# Applicant's A.22(2A)(b) Response Statement to South Dublin County Council LRDOP005/24 LRD Opinion

Residential Development with Crèche at Woodtown, Ballycullen, Dublin 16.

Prepared on behalf of  
Lagan Homes Ballycullen Ltd

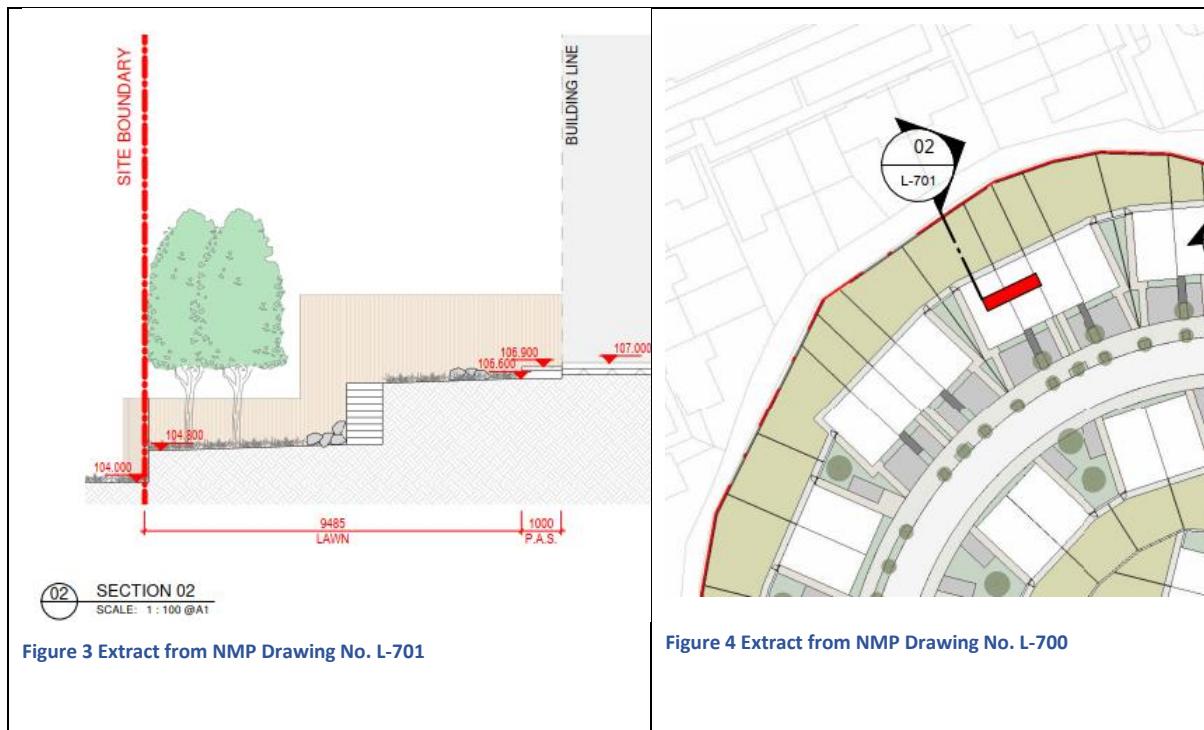
The small sliver of land running between the northern and western boundaries of the site and the adjoining residential estates and how this area will be accessed/maintained and protected. It should be noted that the Planning Authority's preference would be that this area of land would be landscaped and would form part of the application site and that full engineering details are provided to confirm how this area will be protected to avoid subsidence.

The land identified by the planning authority is not within the ownership or control of the applicant. These lands form part of the Abbots Grove development. As illustrated on NMP drawing L-701 it is proposed to provide a step-down in the rear gardens of proposed housing in this location to remove any need for retaining along this boundary. There will be no structural works proposed on the boundary.

Figure 7 Extract from JFOC Drawing No. 1003

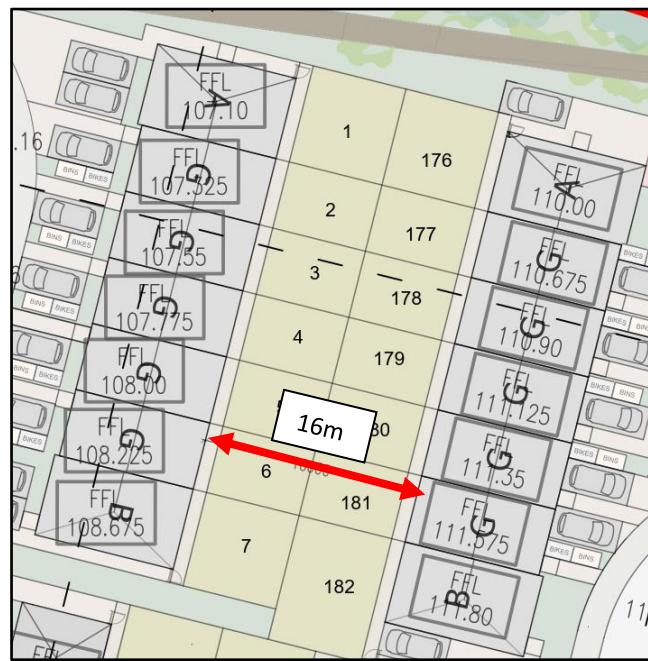
*For the final application, the applicant should ensure that there are adequate separation distances between both the existing and proposed units in line with the Sustainable and Compact Settlements Guidelines for Planning Authorities, (2024).*

Separation distances of at least 16-metres are maintained between first floor opposing windows within the site and between proposed and existing housing to the east and north of the proposed development. Detailed cross sections have been prepared to clearly demonstrate how the proposed development relates to existing residential properties as well as proposed units as detailed above.
